SECTION 53 COMMENTS NATIONAL GRID RESPONSE

Project	Waikanae North Development
Application reference	FTAA-2603-1194
Site	169-171 Peka Peka Road, Waikanae, Kapiti Coast
Document	Response to comments received under section 53, Fast-track Approvals Act 2024 National Grid
Prepared by	Joseph Harris, Landlink Ltd Ray O'Callaghan, O'Callaghan Design Ltd
Date	10 August 2026
Status	Final

2911-S1-001-A

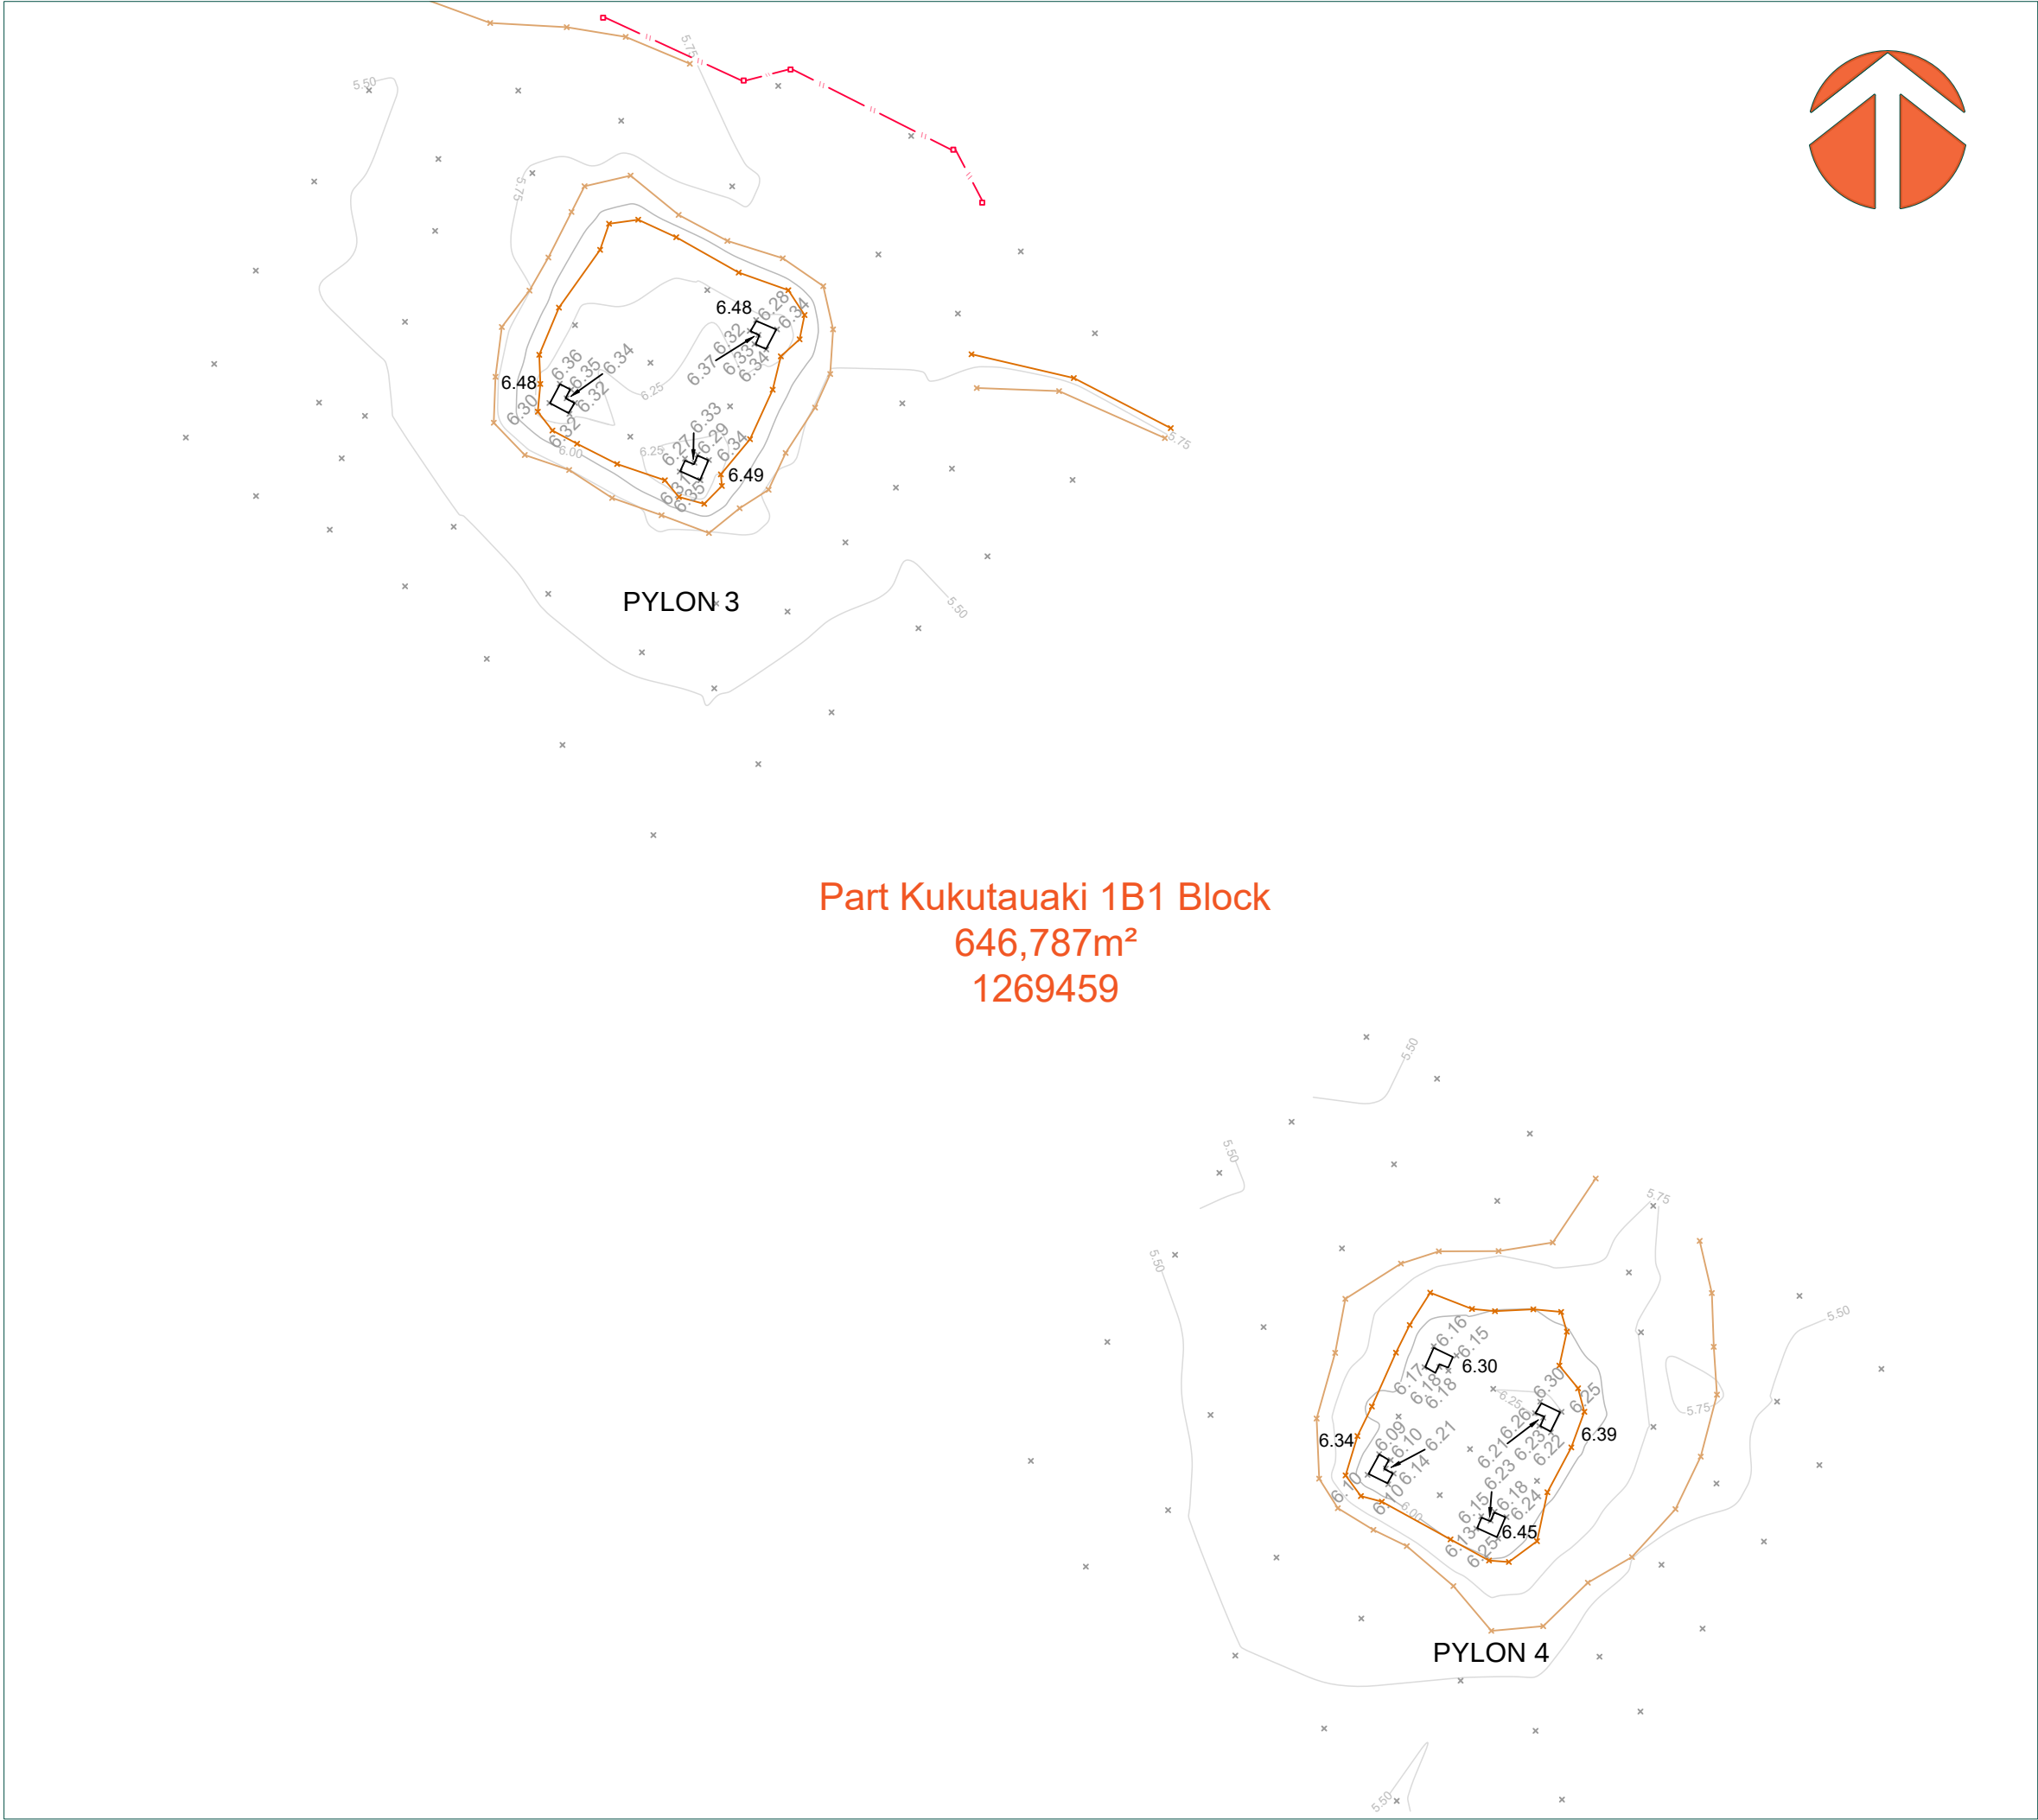
"Transpower requests that the Applicant provide a site-specific assessment of the effects of the proposed development on floodwater levels and ponding around National Grid support structures BPE-HAY-A0244, BPE-HAY-A0245, BPE-HAY-A0246, BPE-HAY-B0230, and BPE-HAY-B0231. This assessment should quantify any change in floodwater depth, extent, duration, and frequency at each support structure location." (paras 4.12–4.15)

Two of the five National Grid support structures are within the existing flood-affected area: BPE-HAY-B-0230 (Pylon 3) and BPE-HAY-A-0245 (Pylon 4). Surveyed top-of-footing levels (2911-S1, 4 August 2026, NZVD2016) are RL 6.48–6.49 m at Pylon 3 (three footings) and RL 6.30–6.45 m at Pylon 4 (four footings). The same survey records surrounding ground levels immediately adjacent to the tower footings as RL6.0 – 6.25. The land slopes away from each of these two towers within the immediate vicinity of each structure and drops to a typical level of RL 5.50. A ground survey was conducted on 04-08-2026 to assist with a greater investigation of ground levels at these two structures to inform this response. The surveyed levels are shown in attached plan 2911-S1-001-A.

The ground levels surveyed immediately surrounding both structures (shown in attached drawing 2911-S1-001-A) are below the modelled existing peak water level for every event, confirming the ground around each tower base already experiences ponding under existing conditions. In other words, the soils in the immediate vicinity of these foundations are already subject to periodic saturation under existing conditions for all 4 modelled flood events. The predicted existing flood water depth in a 2-year event is RL5.83. Although this level is 0.2 – 0.4m below the ground level at the base of the aboveground section of the concrete footings, it is at a level where it is within 2m distance from the tower footings, and thus sufficiently close that it is likely to have some influence on existing soil behaviour in flood conditions (if the soils are such that they are influenced by saturation). The flood water depth and proximity of the existing flood water to the concrete footings increases for the 10-year, 50-year and 100-year design rainfall events.
